No. EC155-63A014

ALERT SERVICE BULLETIN

MAIN ROTOR DRIVE - Change of pressure switch of the dual pump MGB oil pressure

Corresponds to modification 0779B39

Figure 1 - Replacement of pressure switch "16E"

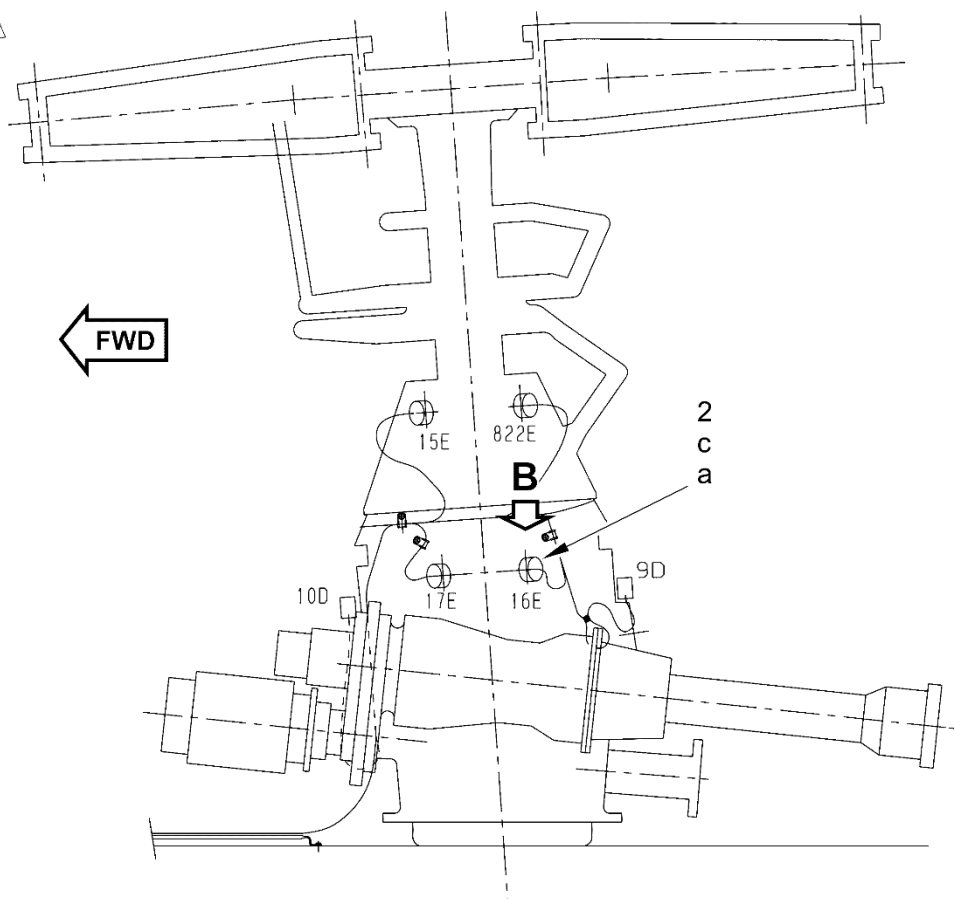
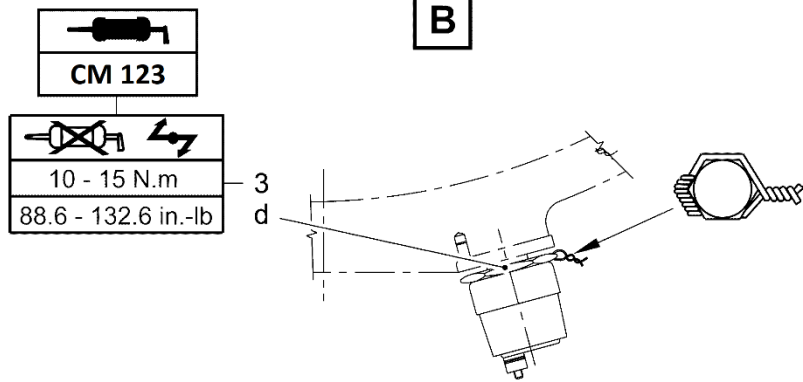
3.B.2.a. Remove the old pressure switch "16E" (Figure 1)

- Disconnect the connector (a) "16E" (Detail A).
- Remove and discard the lockwires (Detail B).
- Remove and store the pressure switch (c) (Detail A).
- Discard the sealing bushes (d) (Detail B).

3.B.2.b. Installation of the new pressure switch "16E" (Figure 1)

- Secure lockwire (1) to the pressure switch (2) (Details A and B).

- Lubricate the sealing bushes (3) with oil (4).
- Install the pressure switch (2) with the sealing bush (3) (Details A and B).

- Tighten to the indicated torque (Detail B).
- Safety the pressure switch (2) to the sealing bush (3) using lockwire (1) (previously secured to the pressure switch (2)).
- Connect the connector (a) "16E" again (Details A and B).
